CLIFFORD OUTFALL
ACROSS CITY OF ALBUQUERQUE LAND FILL SITE

TITLE: CLIFFORD OUTFALL
PLAN & PROFILE - OUTFALL CHANNEL

CITY OF ALBUQUERQUE	
MUNICIPAL DEVELOPMENT DEPARTMENT	
ENGINEERING DIVISION	
TITLE:	CLIFFORD OUTFALL MISCELLANEOUS DETAILS

CURVE DATA

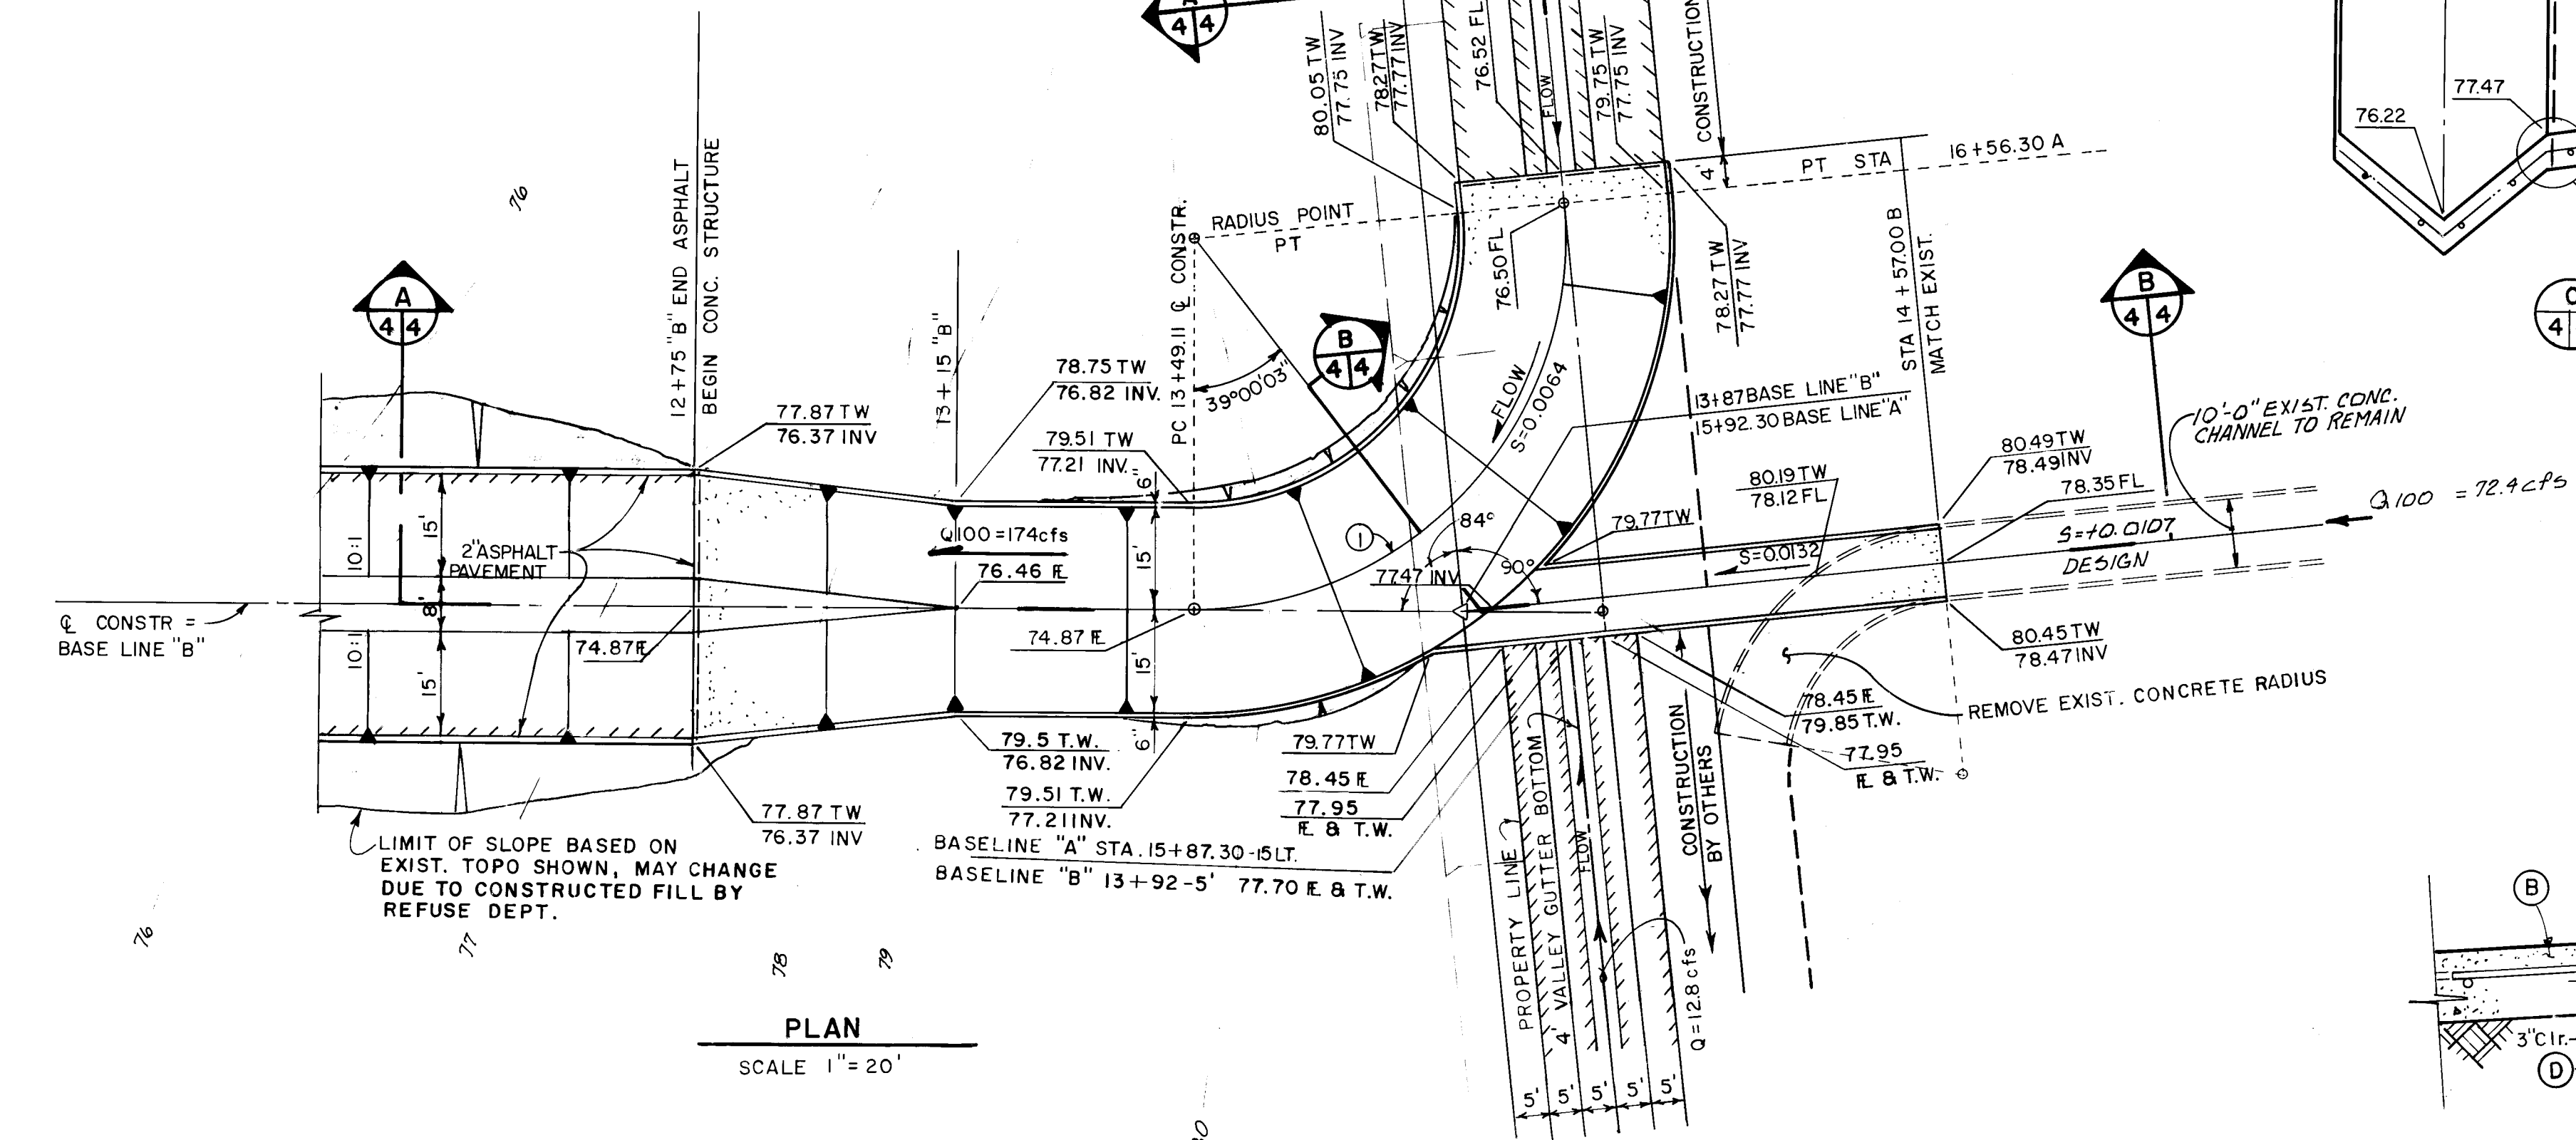
- *** PLAN CORRECTION TO MATCH BID
PROPOSAL. 5/30/85

- 9" EXISTING MATERIAL ABOVE LAND FILL.
- * SECTION 115.04 OF THE SUPPLEMENTAL
TECHNICAL SPECIFICATIONS FOR ASPHALT MIX
REQUIREMENTS ARE REVISED TO READ, BY ADDING:
CHANNEL ASPHALT

1. STABILITY (Marshall - 75 Blows / Face) _____ 1000
2. PER - CENT VOIDS _____ SHALL NOT EXCEED 4 %
3. PER - CENT ASPHALT CEMENT _____ 6.5 - 9.0
4. COMPACTION % OF LAB DENSITY _____ 95 % MIN.

- PROPOSED MIX DESIGN SHALL BE SUBMITTED TO
THE CITY ENGINEER'S OFFICE FOR REVIEW
AND APPROVAL PRIOR TO CONSTRUCTION.
- * PAVING FABRIC SHALL CONFORM WITH SECTION

413.01 THRU 413.03.11 OF THE 1984 EDITION OF
THE NEW MEXICO STATE HIGHWAY DEPARTMENT -
STANDARD SPECIFICATIONS FOR ROAD AND BRIDGE
CONSTRUCTION. SAID SECTIONS TO BE INCORPORATED
INTO THESE CONTRACT DOCUMENT BY THIS REF-
ERENCE. MEASUREMENT PAYMENT SHALL CONFORM
AS SET FORTH IN THE BID PROPOSAL.
